SERVICE BULLETIN

Description: Loud Speaker 300/600W External	
Service Manual: ASM-LS	Service Bulletin No.: ASM-LS-603-0003
ECO No.: ECO# 1180	Subject: Bell Stop Drill Procedure

Figure 3 — Example of Stop Drill

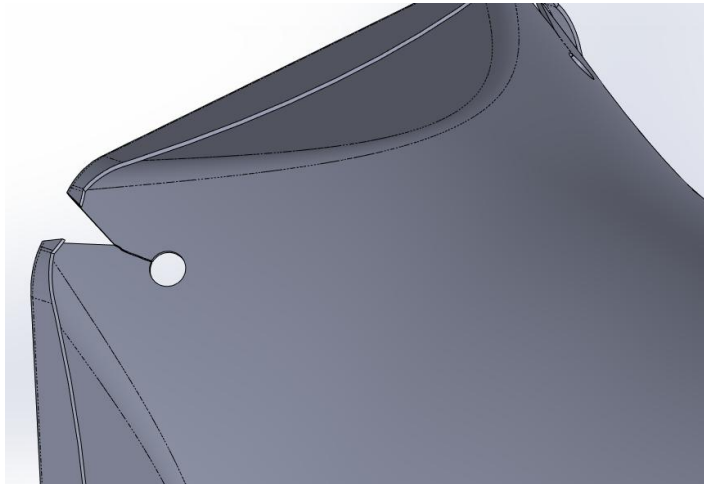
- 2.1.2 To complete the following repair, the crack must be ≤ 2 inches long. If the crack is > 2 inches, the bell must be replaced and cannot be repaired with a stop drill. See service bulletin ASM-LS-603-0004 for bell replacement.
- 2.1.3 Remove and discard any loose material, or material suspected to become loose as shown in Figure 2.
- 2.1.4 Locate the tip of the crack by unaided visual inspection. Drill a 0.1 inch diameter hole beyond the visible crack tip in the path of the crack as shown in Figure 3.

- 2.1.5 Enlarge the 0.1 inch diameter hole to a 0.31 inch diameter hole (if restricted due to location of crack tip, drill the largest hole possible up to a maximum diameter of 0.31 inches).
